# IRON HAMMER - SITE PLAN AMENDMENT

A PORTION OF LOTS 1 & 2, BLOCK 1, AURORA CENTRETECH PARK SUBDIVISION FILING NO. 8, LOCATED IN THE NORTHWEST QUARTER OF SECTION 8, TOWNSHIP 4 SOUTH, RANGE 66 WEST OF THE 6TH P.M., CITY OF AURORA, COUNTY OF ARAPAHOE, STATE OF COLORADO

PROJECT #	IH2215
PROJECT DATE	04/28/2023
DESIGNER	SAK
REVIEWER	JSD

## LANDSCAPE PLAN

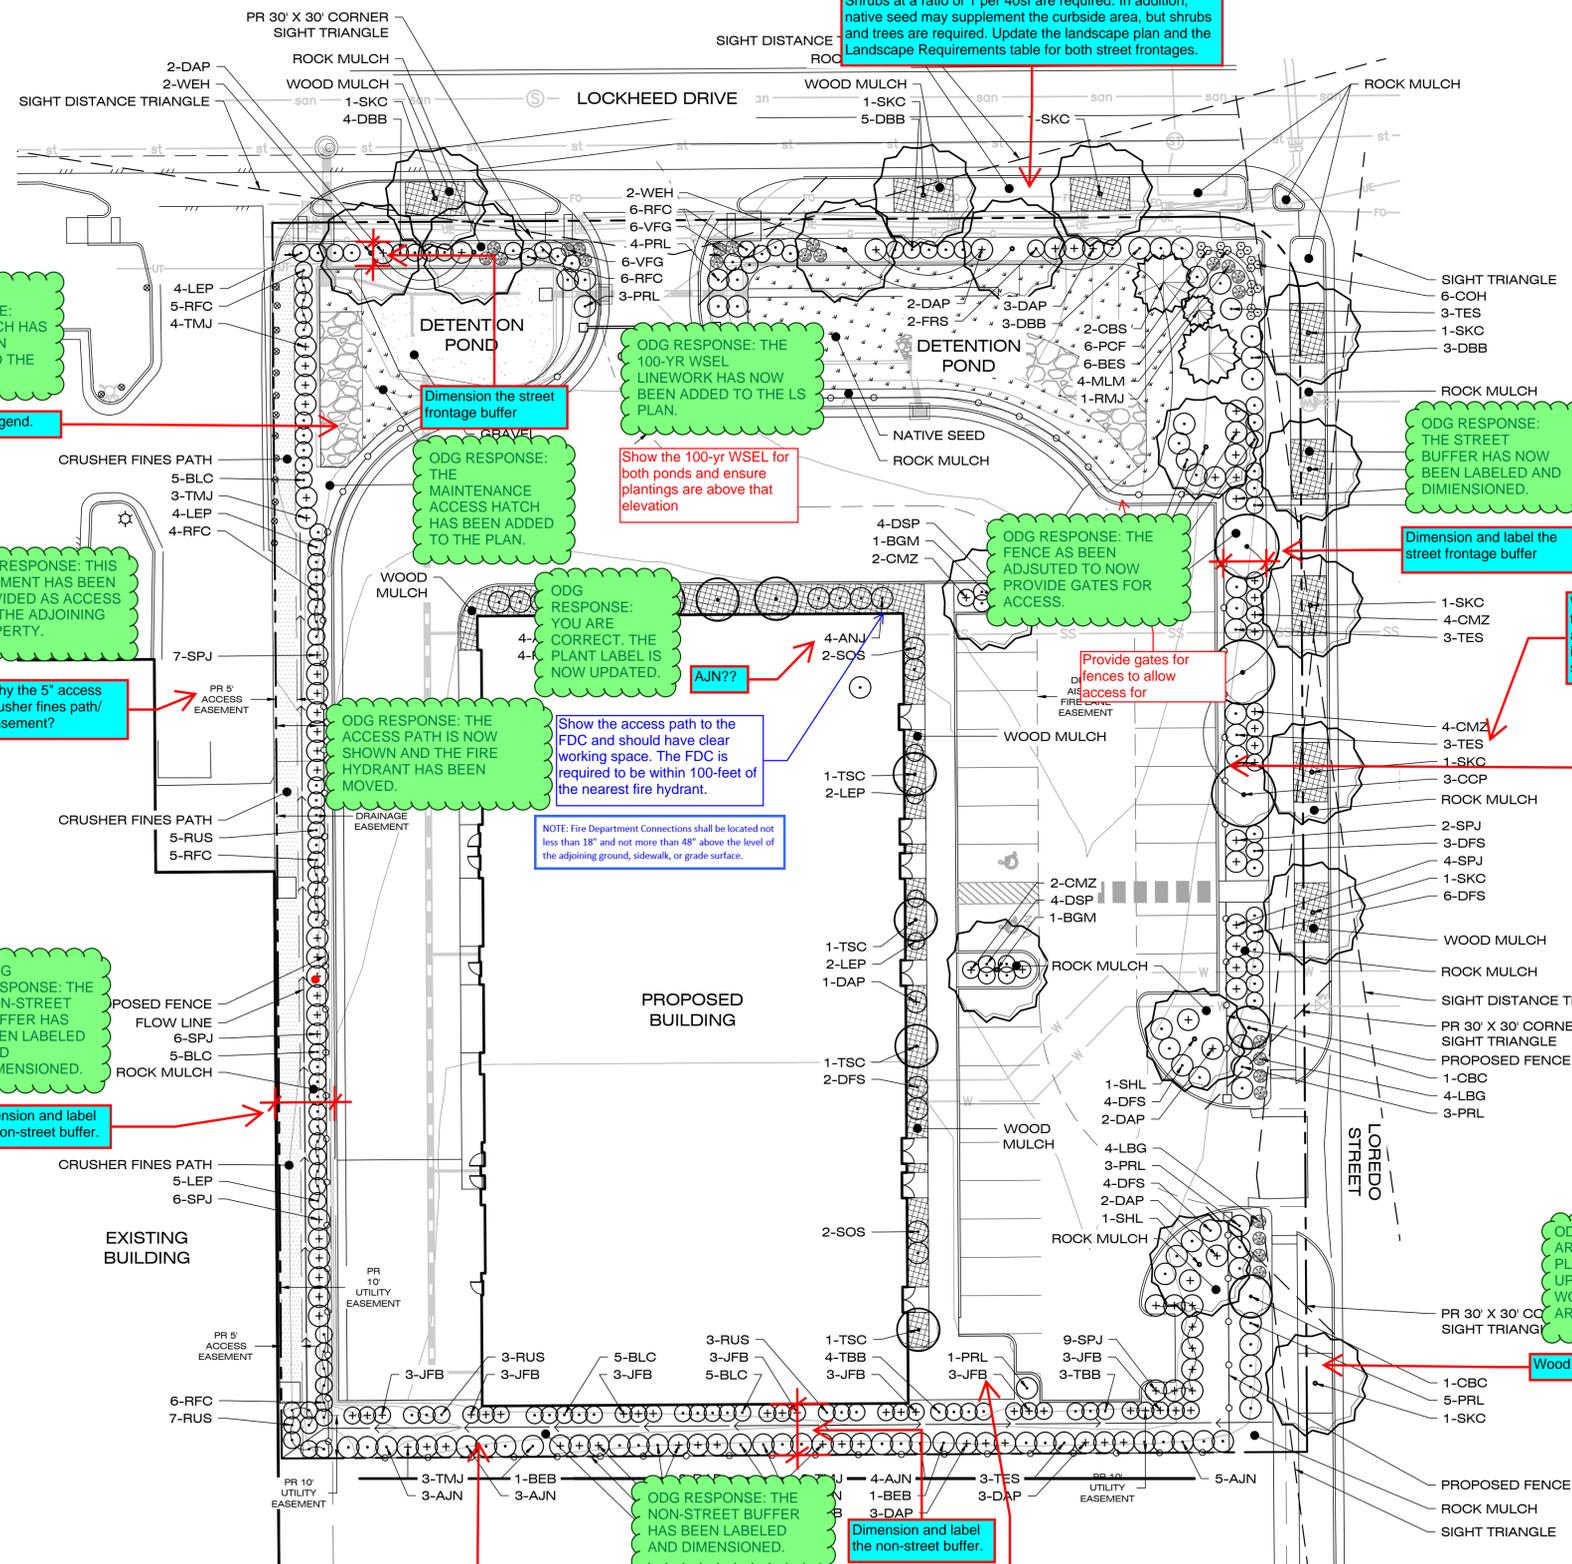
Darken the edges of the sidewalks along both streets.

The street frontage buffer does not appear to be met along Lockheed Drive. An adjustment will be required. Detention ponds are not permitted to encroach within the required buffers. Update the Letter of Introduction to include the landscape adjustment and provide information on the mitigating measures being taken to offset the adjustment request. List the adjustment request on the Cover Sheet and the Landscape Plan as well.

Add to the legend.

Why the 5' access crusher fines path/easement?

Dimension and label the non-street buffer.

Per code, the landscaping is supposed to be located along the exterior side of the fence so that the adjoining future development is not looking at a blank surface.

Dimension and label the non-street buffer.

Provide a tree for the outdoor patio space and it would satisfy the requirement that all parking rows are to terminate with a tree.

Per code, the curbside landscape may not be all mulch. Shrubs at a ratio of 1 per 40sf are required. In addition, native seed may supplement the curbside area, but shrubs and trees are required. Update the landscape plan and the Landscape Requirements table for both street frontages.

Show the 100-yr WSEL for both ponds and ensure plantings are above that elevation

Provide gates for fences to allow access for

Show the access path to the FDC and should have clear working space. The FDC is required to be within 100-feet of the nearest fire hydrant.

Dimension and label the street frontage buffer

Why not either do the TES or the SPJ as the background tall plant? The aesthetic along the street would be more consistent instead of having a random group of tall shrubs i.e. SPJ.

Add this symbology to the legend. It appears to be a fence. Label as 4', 6' etc. wooden/trex etc. fence.

Due to the remoteness of existing fire hydrants, a new hydrant will be required on the property and meet the 100-foot distance to the FDC on the building.

Wood mulch??

ODG RESPONSE: SIDEWALK EDGES HAVE BEEN DARKENED ON THE LS PLAN

ODG RESPONSE: THE LOCKHEED DRIVE ODG RESPONSE: THE LOCKHEED DRIVE STREET FRONTAGE BUFFER LANDSCAPE REQUIREMENTS ARE NOW MET WITH THE NEW DESIGN. NO ADJUSTMENT WILL BE NECESSARY

ODG RESPONSE: THIS HATCH HAS NOW BEEN ADDED TO THE LEGEND.

ODG RESPONSE: THIS EASEMENT HAS BEEN PROVIDED AS ACCESS FOR THE ADJOINING PROPERTY.

ODG RESPONSE: THE NON-STREET BUFFER HAS BEEN LABELED AND DIMENSIONED.

ODG RESPONSE: THE FENCE HAS BEEN APPROVED TO BE ON THE INTERIOR OF THE FENCE AS LONG AS FENCING WITH GAPS HAS BEEN PROVIDED. SEE FENCE DETAIL ON LANDSCAPE PLAN SHEET 6.

ODG RESPONSE: THE NON-STREET BUFFER HAS BEEN LABELED AND DIMENSIONED.

ODG RESPONSE: A TREE HAS BEEN ADDED TO THE PLAN FOR THE PATIO AREA.

ODG RESPONSE: THE 100-YR WSEL LINEWORK HAS NOW BEEN ADDED TO THE LS PLAN.

ODG RESPONSE: THE MAINTENANCE ACCESS HATCH HAS BEEN ADDED TO THE PLAN.

ODG RESPONSE: THE FENCE AS BEEN ADJUSTED TO NOW PROVIDE GATES FOR ACCESS.

ODG RESPONSE: YOU ARE CORRECT. THE PLANT LABEL IS NOW UPDATED.

ODG RESPONSE: THE STREET BUFFER HAS NOW BEEN LABELED AND DIMENSIONED.

ODG RESPONSE: PLANTINGS HAVE BEEN ADJUSTED TO CREATE A MORE COHESIVE LOOK

ODG RESPONSE: FENCE AND WALL SYMBOLS HAVE BEEN ADDED TO THE PLAN.

ODG RESPONSE: A NEW FIRE HYDRANT HAS BEEN ADDED TO THE PROPERTY

ODG RESPONSE: YOU ARE CORRECT. THE LS PLAN HAS BEEN UPDATED TO SHOW WOOD MULCH IN THIS AREA.
